ASMER HOUSE | ROOF SUPPORT LAYOUT ON CLIENT GA

P03 · ENGINEER REVIEW · ALL DIMENSIONS IN mm · WRITTEN SURVEY DIMENSIONS GOVERN · DO NOT SCALE

KA-ASM-SK-003 | P03 | Sources: Survey Notes p3, GA 200 Rev A (PDF p3), and engineering lead clarifications | A3 landscape

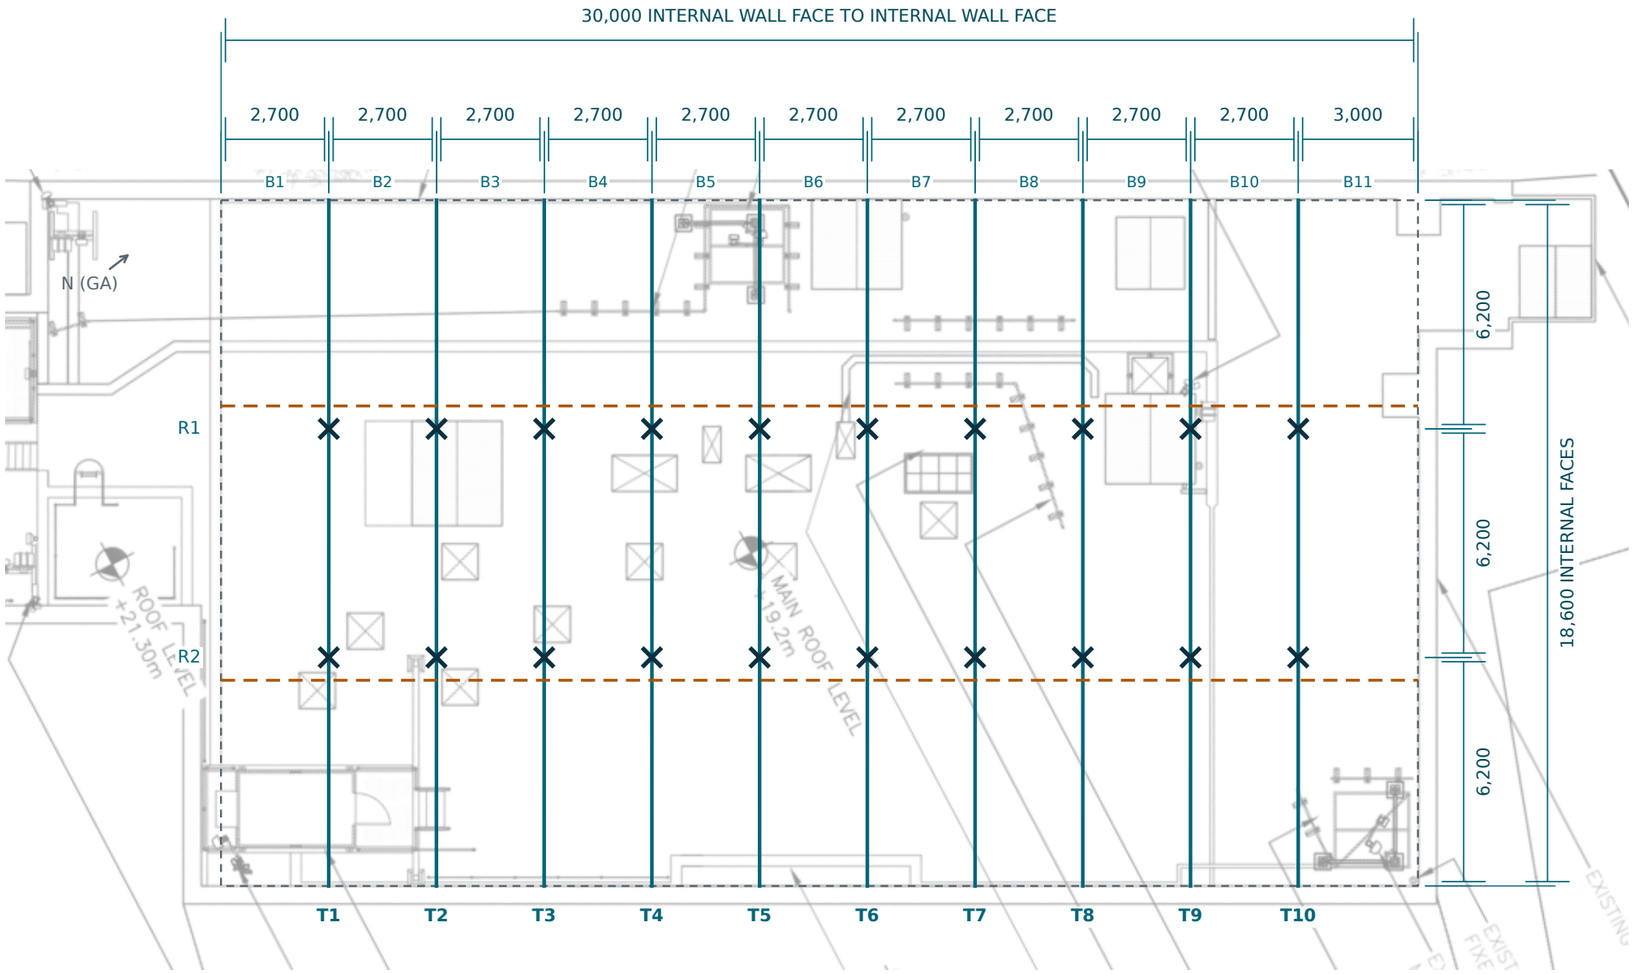
MAIN RECTANGLE ONLY — STEPPED SECTIONS AT BOTH ENDS EXCLUDED

B1: internal wall face → T1 centreline. B2–B10: beam centreline → beam centreline. B11: T10 centreline → internal wall face.

Across roof: internal wall face → R1 column centreline → R2 column centreline → internal wall face; each span 6,200.

1. Blue solid lines: 10 internal transverse beams. Crosses: 20 internal columns. T1–T10 and R1/R2 are introduced review labels.
2. Orange dashed lines: longitudinal beams, continuous for this sketch and connected to transverse beams, not directly to columns.
   Their displayed offsets are schematic only; exact positions and section sizes were not verified. End details are unverified.
3. Transverse beam ends are assumed to terminate at external load-bearing walls; actual support details unverified. End-wall beams not confirmed.
4. Original GA retained as context, rotated for readability. Member marks are diagrammatic; no PDF-scale dimensions or setting-out coordinates inferred.
5. Review the selected main-rectangle extent and member arrangement. This sheet is not structural approval and is not for construction.
